City of Beverly Hills

Design Review Commission Report

Subject: **144 South Almont Drive (PL1318426)**

A request for an R-1 Design Review Permit to allow for construction of a new two-story single-family residence located in the Central Area of the City south of Santa Monica Boulevard. The Commission will also consider adoption of a Categorical Exemption, pursuant to the California Environmental Quality Act.

SHEET TITLE
FRONT & SOUTH ELEVATIONS

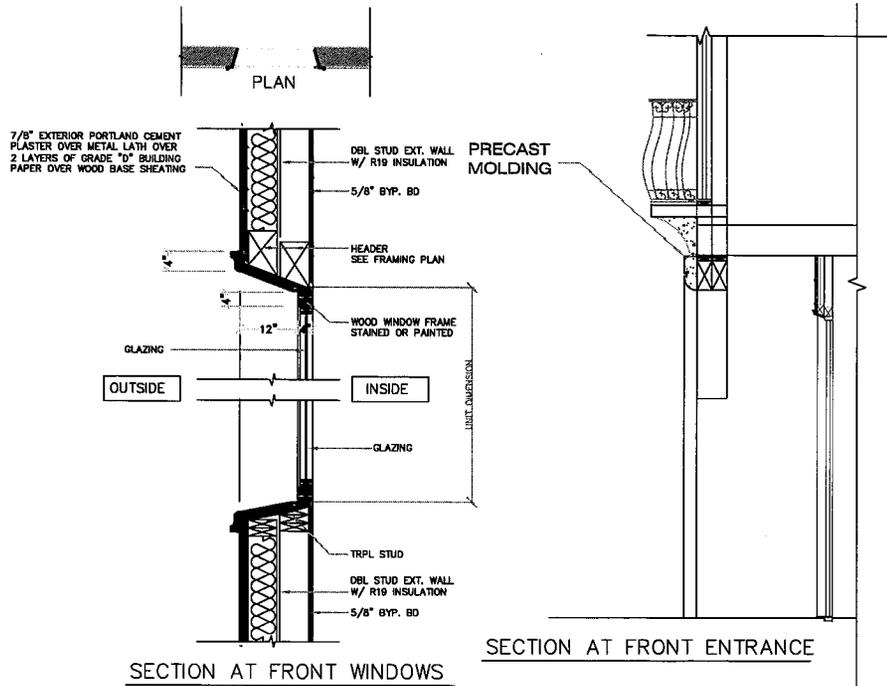
Based on a review conducted by the City's Urban Designer, the proposed design lacks authenticity in style and composition as it lacks the typical Spanish Colonial characteristics. The design is an inappropriate fenestration of design aesthetic and details, particularly in the spacing of windows in relation to the overall façade and the lack of human scale. The window choices do not complement the purported style. Additionally the eaves and roof pitch are not appropriate for a Spanish Colonial residence.

As such, it is recommended that the Design Review Commission consider the design concerns and direct the project to be returned to a future meeting so the design aesthetic and details can be redesigned.
